UNITED STATES PATENT AND TRADEMARK OFFICE

APPLICATION NO.	FILING DATE	FIRST NAMED INVENTOR	ATTORNEY DOCKET NO.	CONFIRMATION NO.
09/710,362	11/10/2000	John C. Connolly	PLW 13206	5398

Office Action Summary

DETAILED ACTION

Fig. 1

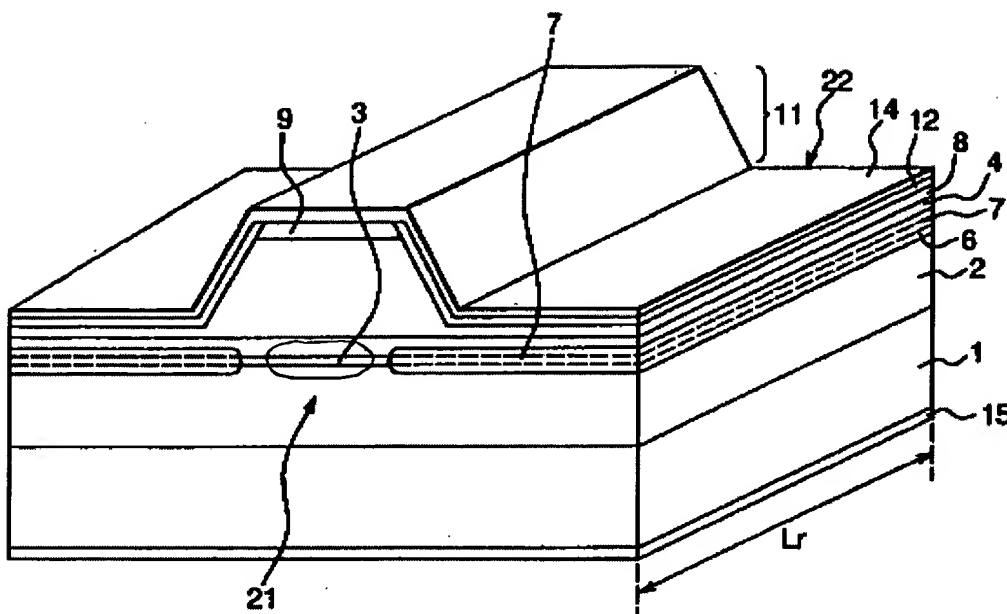
Regarding claim 1, Nagai discloses a ridge waveguide semiconductor laser diode comprising a first conductor layer 14, a second conductor layer 15 facing the first conductor layer, an active layer 3 disposed between the conductor layers, a gain region of the active layer (circled in red below), and reduced conductivity regions 7 of the

active layer flanking the gain region and for impeding the passage of current (Fig. 1 and discussion thereof).

Regarding claim 11, an insulator 12 is disposed adjacent to the first conductor layer (see Fig. 1 above).
